DE-4000 Terminal Module Improvements

The 691760 Terminal Module has been updated with the ability to eliminate the use of the jumpers on the terminal strip by using a DIP switch setting. This improved Terminal Module is noted by "R1" next to the part number on the board and is 100% backwards compatible with the original version. There are added graphics on the label denoting these new switch settings and the Installation Instructions are also updated to show the new settings. Retrofits can use the original jumpers, or they can be removed and DIP switch settings can be set to replace the jumpers. "R1" Terminal Modules will NOT be shipped with jumpers since the switch settings would eliminate them on new applications.

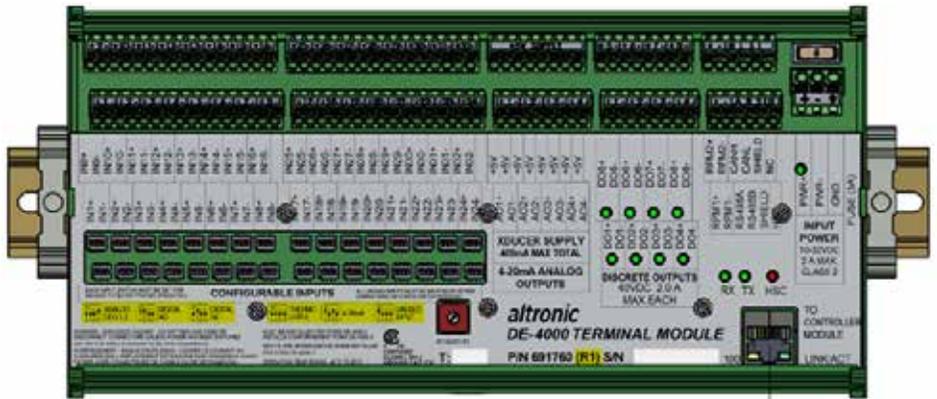
An additional improvement was also made to "R1" to incorporate short circuit protection to the 4-20mA outputs. This improvement is transparent and in no way affects the use, calibration or retrofit from the original Terminal Module to the "R1" Terminal Module.

*Be sure to note the changes to the DIP switch settings when replacing a Terminal Module. Digital NO, 4-20mA and Unused Inputs have different settings than the legacy Terminal Module.

1. N/O SENSOR SWITCH AND 4-20mA MUST HAVE SW POS 1 ON OR HAVE SHUNT JUMPER IN PLACE BETWEEN INx (+) AND INx (-) OF TERMINAL BLOCK. POWER SUPPLY MINUS AND SENSOR GROUND MUST BOTH BE COMMON.

2. N/C SENSOR SWITCH, REMOVE JUMPER AND PLACE SWITCH WIRES, ONE IN (+) OTHER IN (-)

3. ALL UNUSED INPUTS MUST BE SHUNTED WITH EITHER SW POS 1 OR A JUMPER.
